Access Compliance Report

Public Rights-of-Way (Curb Ramps)

Intersection ID: 44169	Main Street: FOUNTAINGRASS_LN	Cross Street: PRAIRIE_VALLEY_DR	Location: SW
ADA ID: 3E77020DE353	Ramp Type: PerpDiag	Initial Pass/Fail: Fail	Overall Compliance: No
		Severity Score: 72.5

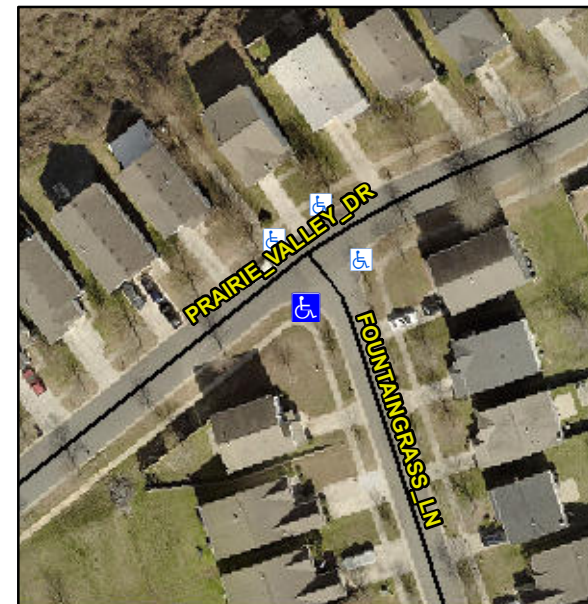
Not Found, R304.5.1, R304.2.2, R304.5.3

Compliance	Description	Data	Compliance	Description	Data
N/A	Ramp Length (in)	85.0	No	Ramp Slope (%)	10.3
No	Ramp Width (in)	27.0	No	Ramp XSlope (%)	13.7
N/A	Flare Type LT	N/A	N/A	Flare Type RT	N/A
N/A	Flare Slope LT (%)	N/A	N/A	Flare Slope RT (%)	N/A
N/A	Flare Traversable LT?	N/A	N/A	Flare Traversable RT?	N/A
N/A	Landing Length (in)	N/A	N/A	DWS Provided?	N/A
N/A	Landing Width (in)	N/A	N/A	DWS Contrast?	N/A
N/A	Landing Slope (%)	N/A	N/A	DWS Length (in)	N/A
N/A	Landing X Slope (%)	N/A	N/A	DWS Full Width?	N/A
N/A	Landing Curb? (Y/N)	N/A	N/A	DWS Offset (in)	N/A
N/A	Shared Landing?	N/A			
N/A	Gutter Ponding?	N/A	N/A	Gutter Slope (%)	N/A
N/A	Gutter Lip Ht (in)	N/A	N/A	Gutter X Slope (%)	N/A
N/A	Painted X Walk1?	No	N/A	Painted X Walk2?	No
	X Walk 1 Direction	To NE		X Walk 2 Direction	To NW
N/A	X Walk 1 Width (in)	N/A	N/A	X Walk 2 Width (in)	N/A
	X Walk 1 Slope (%)	4.0		X Walk 2 Slope (%)	5.5
	X Walk 1 X Slope (%)	6.6		X Walk 2 X Slope (%)	6.2

N/A	Ramp inside XWalk1?	N/A	N/A	Ramp inside XWalk2?	N/A
	Road Slope (%)	6.2	N/A	Clear Space?	N/A
	Road X Slope (%)	0.3	N/A	Clear Space to XWalk (in)	N/A
N/A	Any Obstructions?	N/A	N/A	Storm Grate/Utility Hazard?	N/A
	Obstruction Type			Storm Grate/Utility Type	
		N/A			N/A
			Yes	Surface Condition? (G/P)	Good

Remove & Replace Curb Ramp With Two New Directional Ramps or Equivalent.
